SI B33 04 16
Rear Axle

SERVICE ACTION: REPLACE REAR-AXLE DIFFERENTIAL

This Service Information bulletin supersedes SI 33 04 16 **dated August 2016**

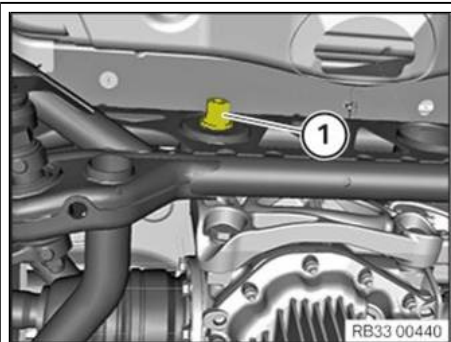
During the repair, when releasing rear differential Hexagonal collar bolt M14x1.5x125 (PN 33 17 7 852 488), make sure that the bolt's hex head does not show any marks indicating previous removal. In case bolt M14x1.5x125 (1) has been removed (torque released) previously, it needs to be replaced together with 4 sub-frame Torx screws M12x60 (PN 33 30 2 284 642).

F8x produced up to 06/28/2016

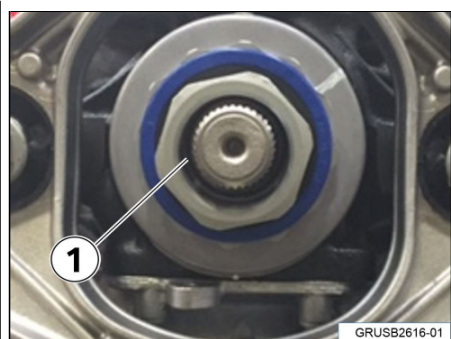
<p>Identifying the 8 090 464 differential: Check the number of splines on the old/new differential. The correct differential has 35 splines (1)</p>
--	--

F8x produced from 06/29/2016

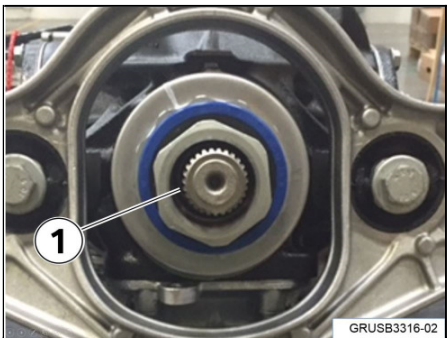
<p>Identifying the 8 090 473 differential: Check the number of splines on the old/new differential. The correct differential has 27 splines (1)</p>
---	--
